# Technical Service Bulletin

**MODEL(S) AFFECTED:** **5680 models equipped with Drive module (PG Drives Technology)**

**SUBJECT:** **Issue #1.** False Battery Discharge Indicator reading. If BDI charge level rapidly drops upon machine start up, the drive module may have a program error. The actual run time is not affected by false BDI reading, the batteries will continue to discharge as normal.

**Drive Module Program Revision Level**

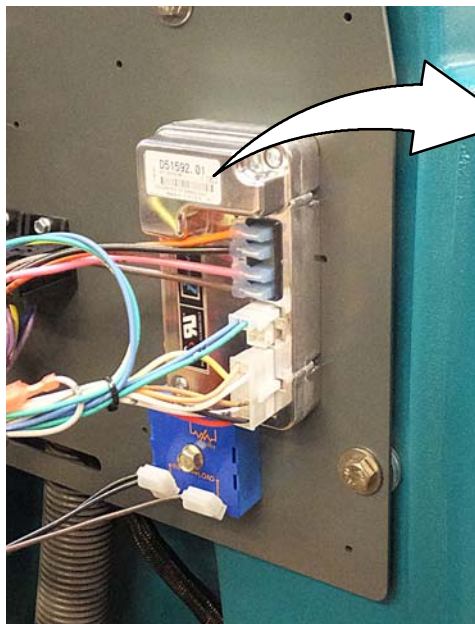
**Issue #2.** Transaxle motor can overheat when overloaded for an extended period.

**NOTE:** The above issues only apply to Drive modules with program revision 01.

**PURPOSE:** To resolve these issues, replace the drive module with program revision 02 or higher (p/n 1212548). The program revision level is identified on the drive module label as shown below.

**Replace drive module with program revision 02 or higher.**  
Replacement drive module part number 1212548.
